**TOWN OF CARMEL
PLANNING BOARD**

**PLANNING BOARD AGENDA
AUGUST 19, 2020 – 7:00 P.M.**

RE: Carmel Fire Department
94 Gleneida Avenue
Town of Carmel
TM# 44.14-1-24

Re: Carmel Fire Department Site Plan

VEHICLE MANEUVERING PLAN WB-62

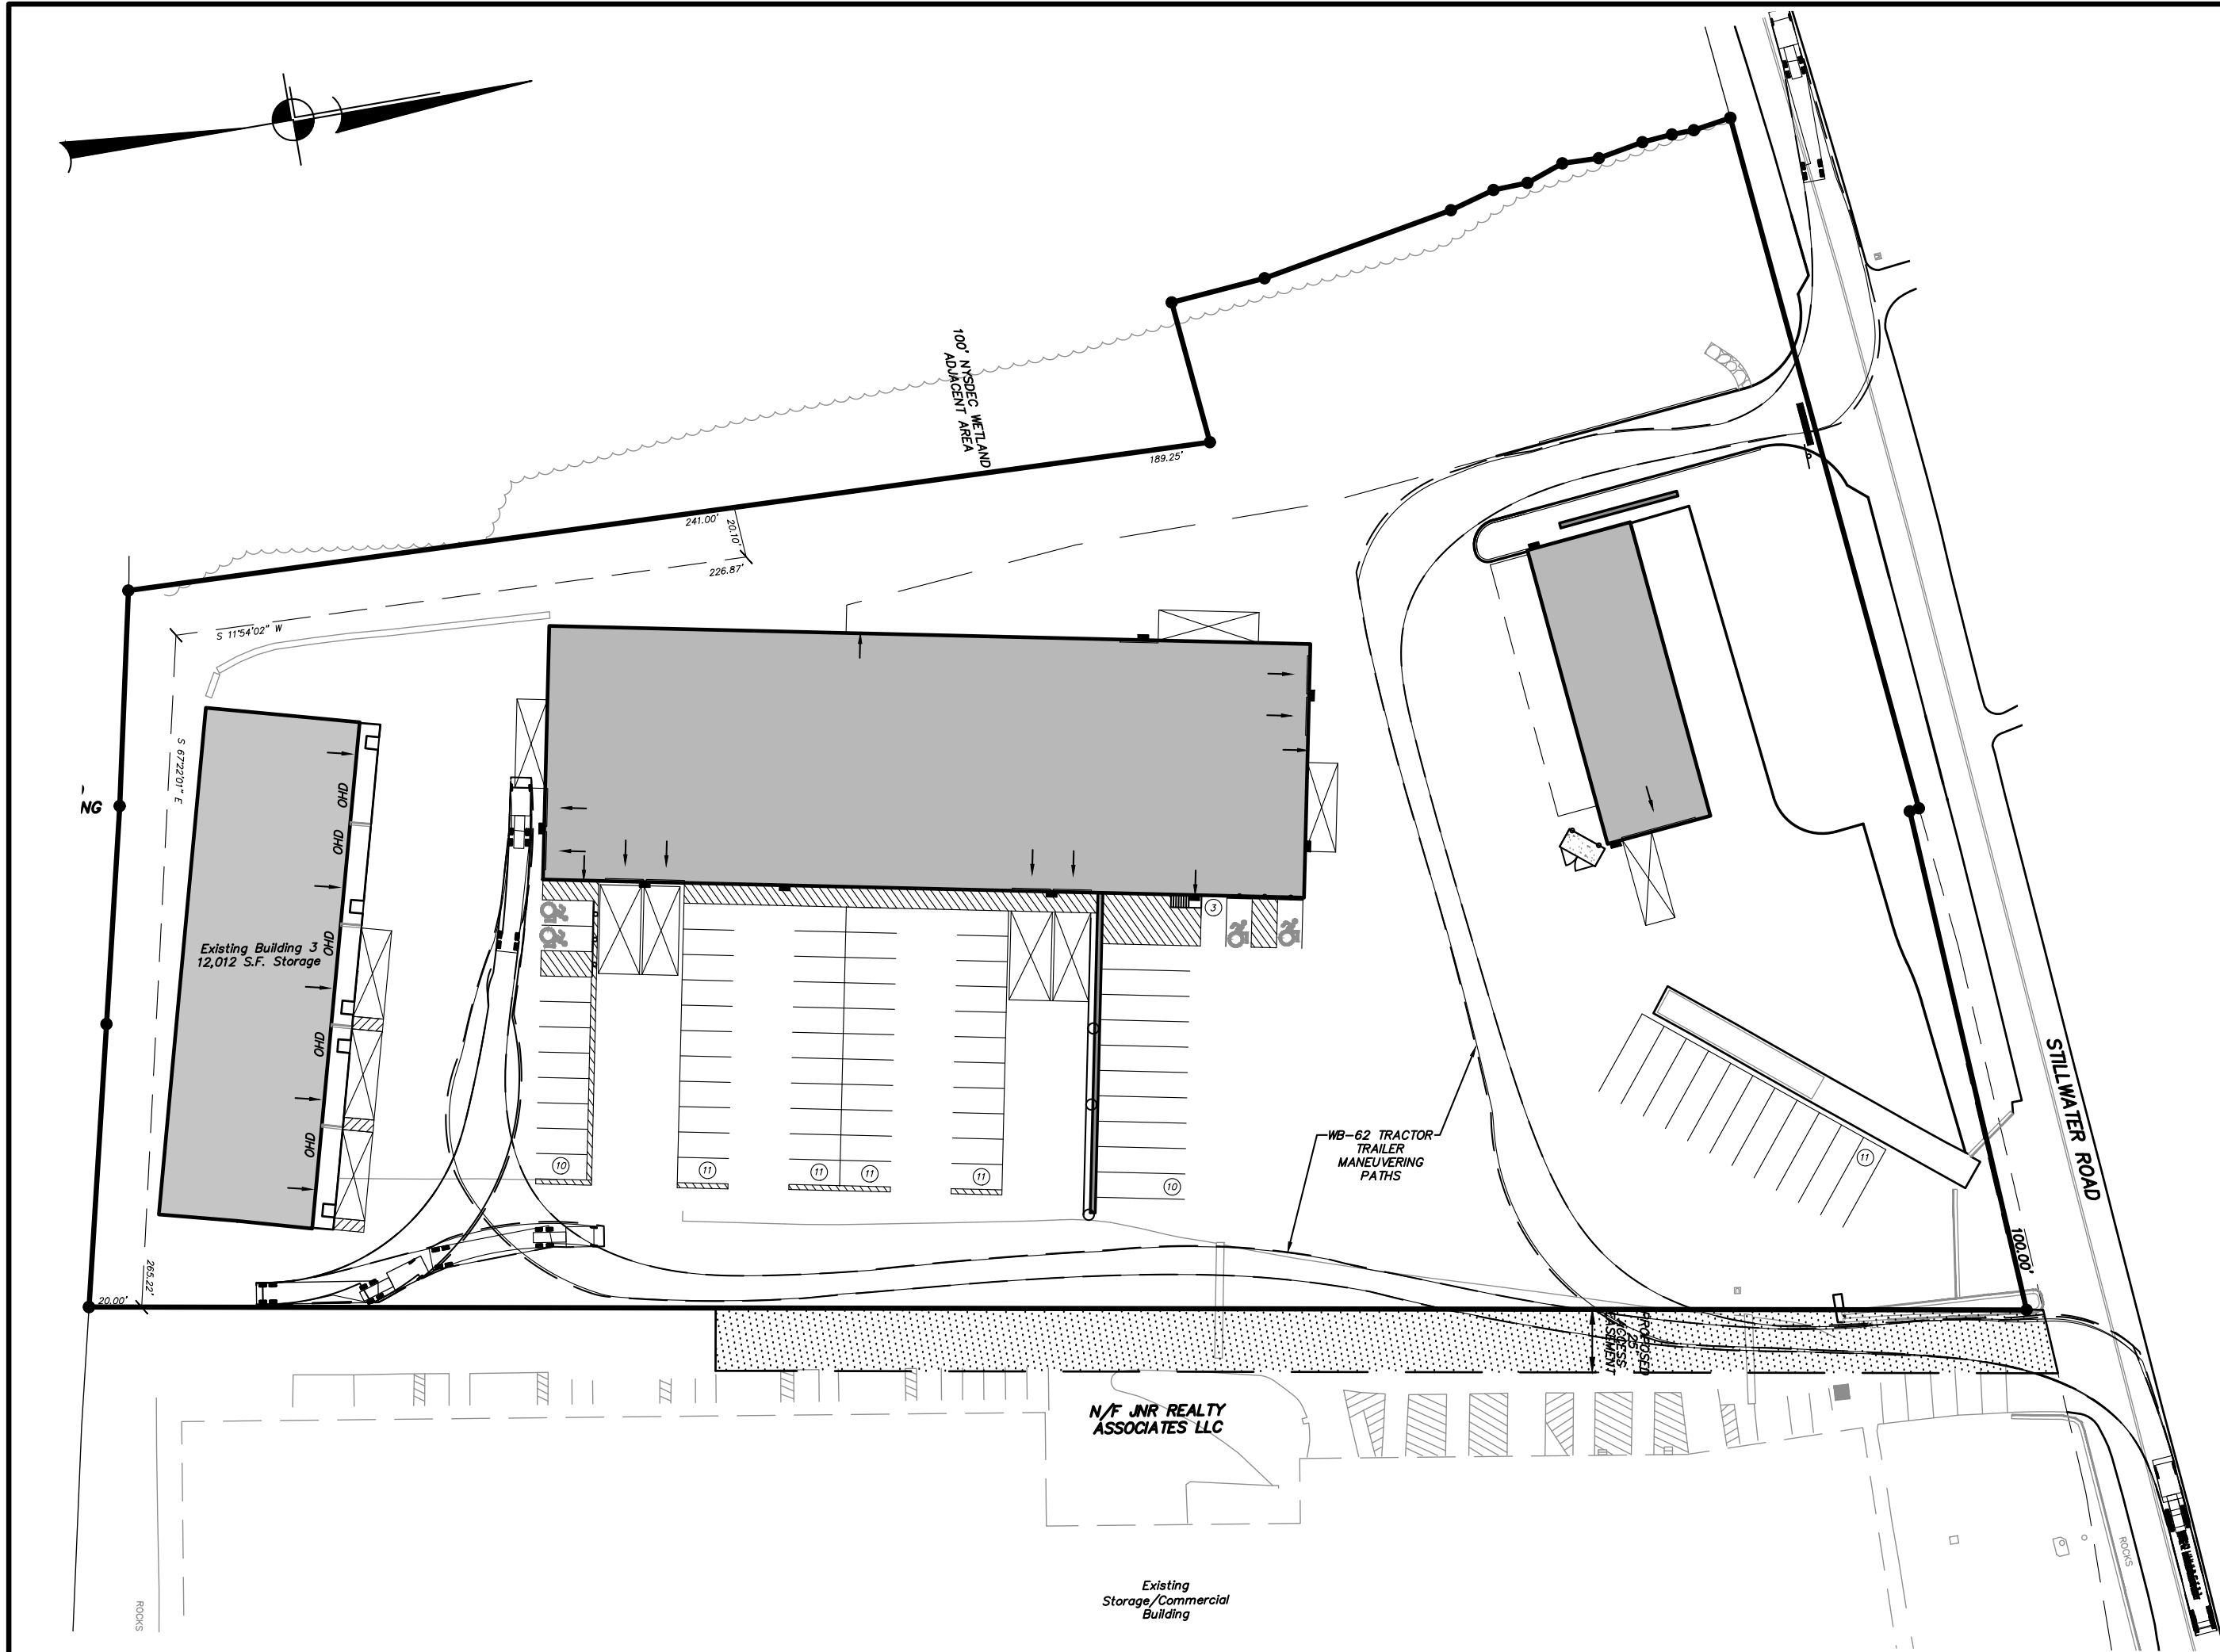
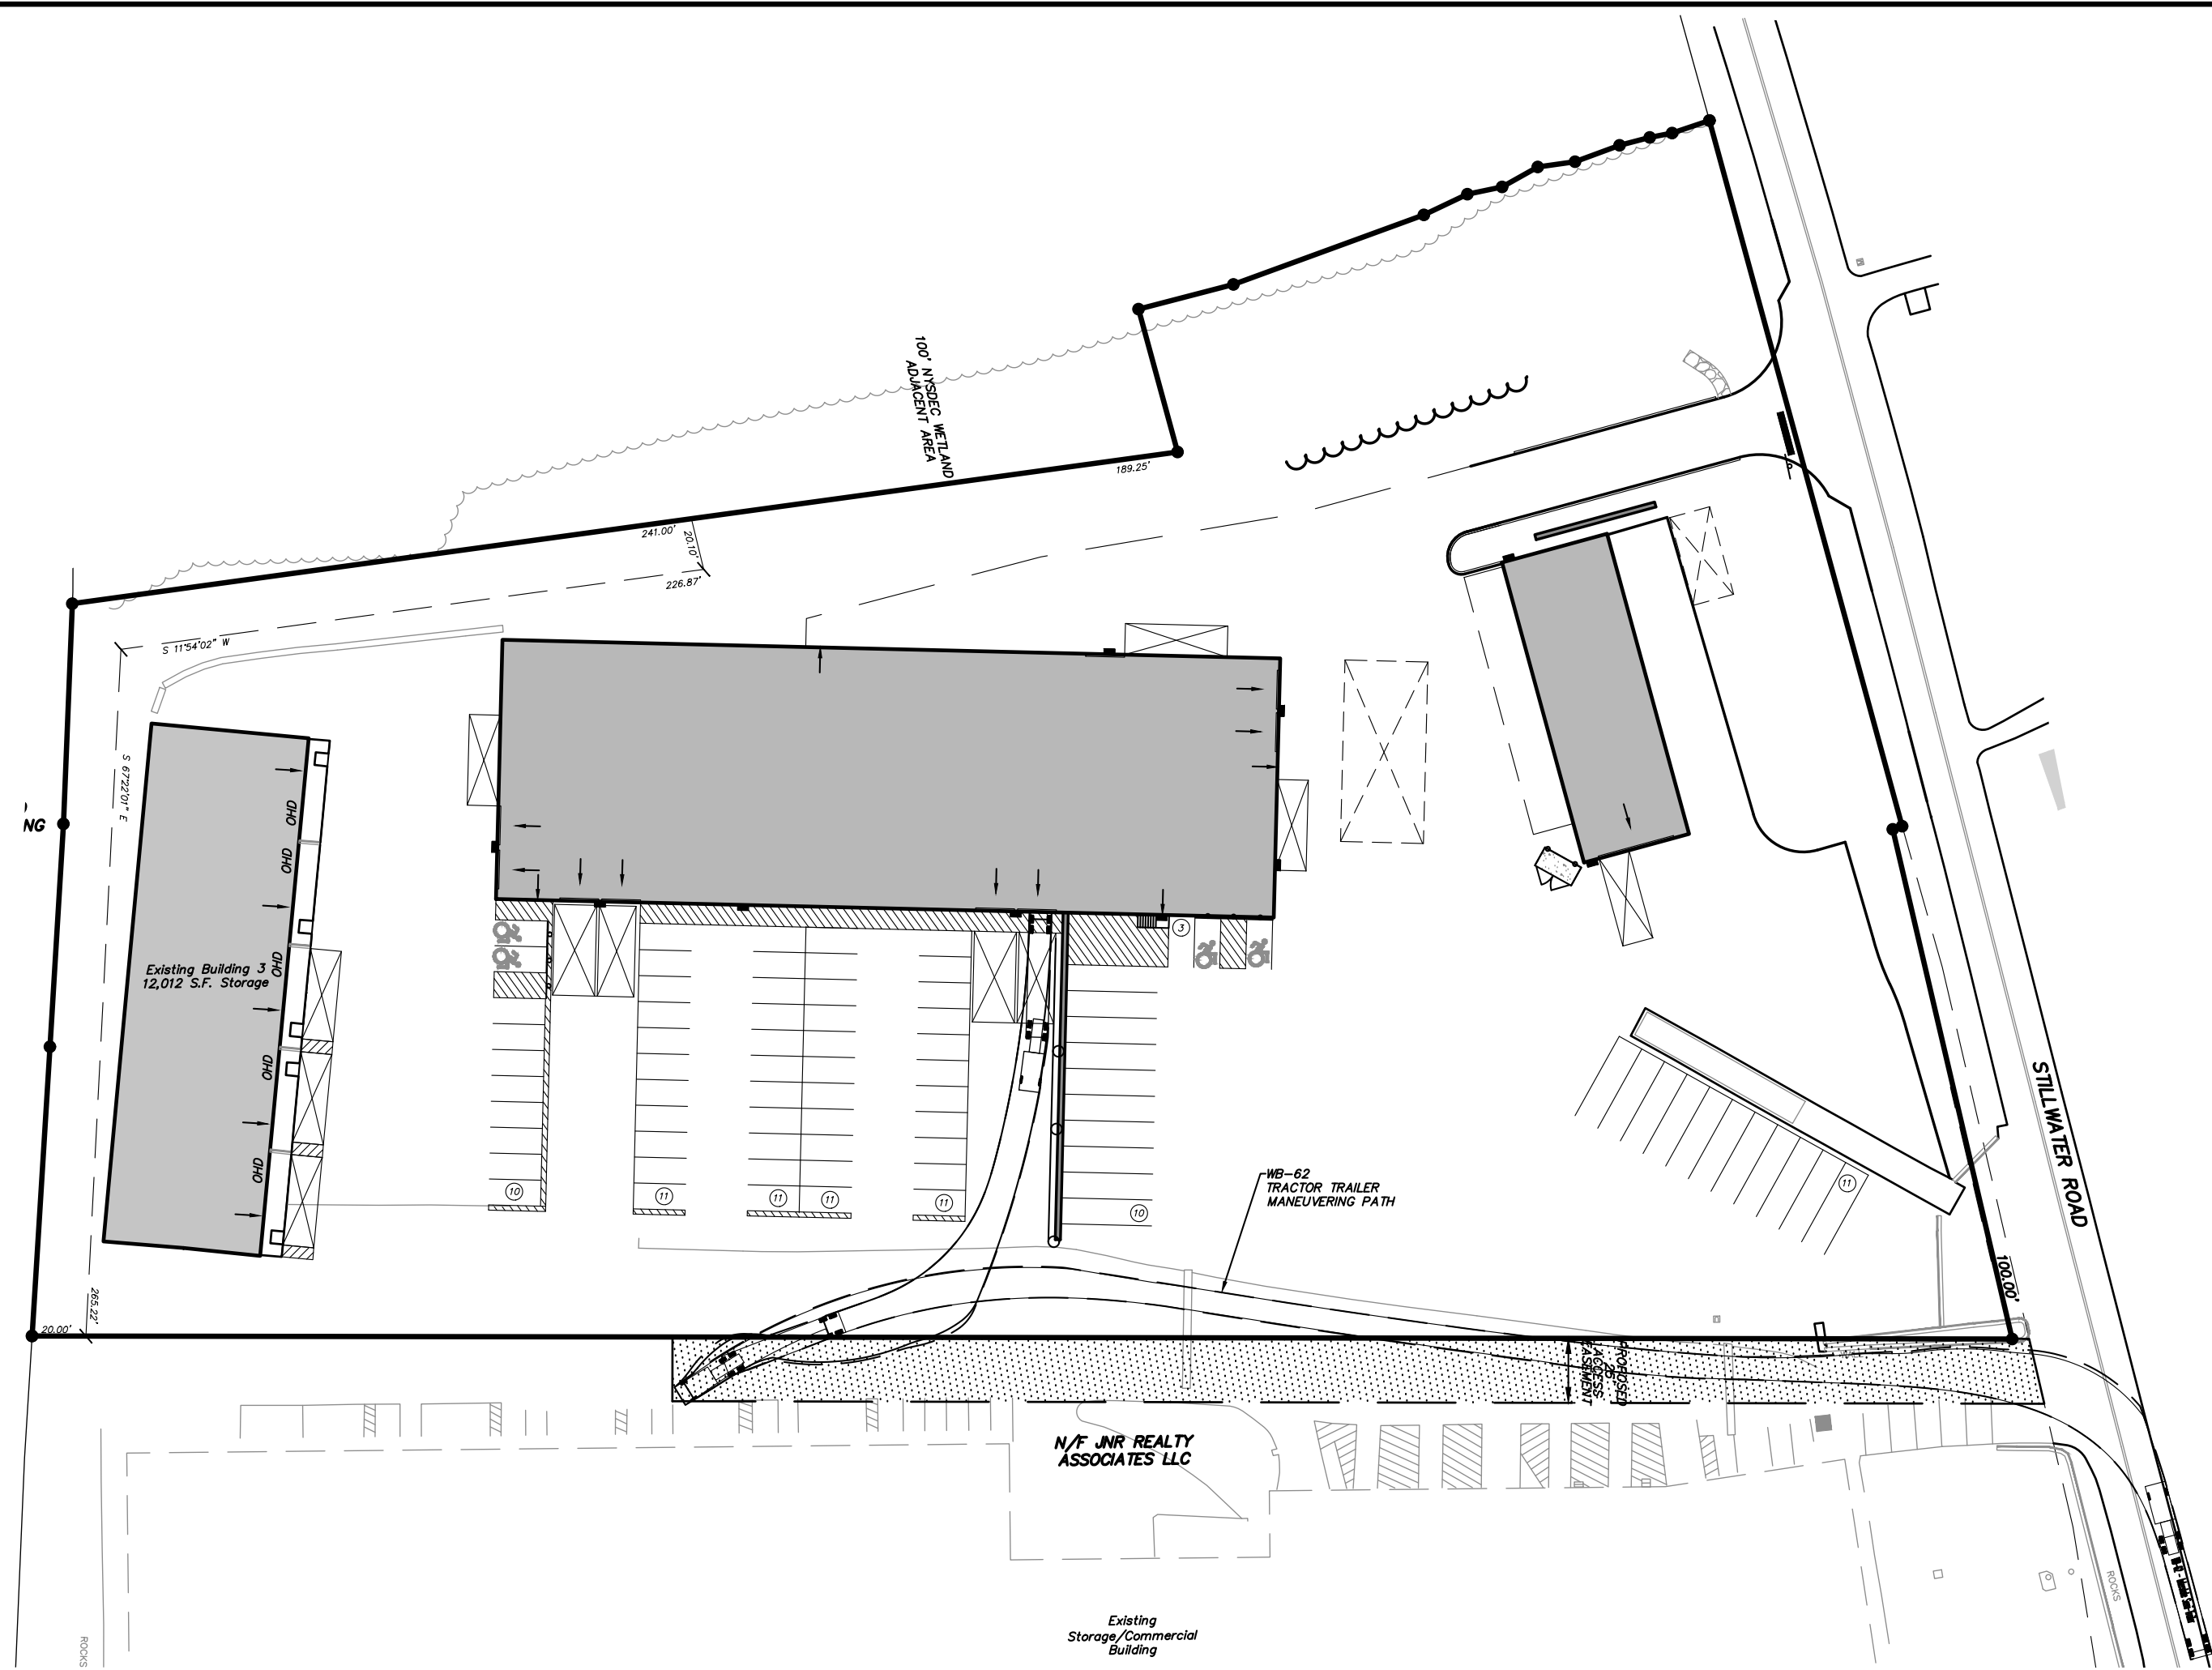
- (4) A Vehicle Maneuvering Plan has been included on sheet SP-4. The plans indicate several maneuvers of a standard WB-62 tractor trailer through the site.

5. A Vehicle Maneuvering Plan has been included on sheet SP-4.
 - a. The plan indicates how a typical WB-62 truck will maneuver through the site.
 - b. A turning radius diagram is provided for the WB-62 on sheet SP-4.
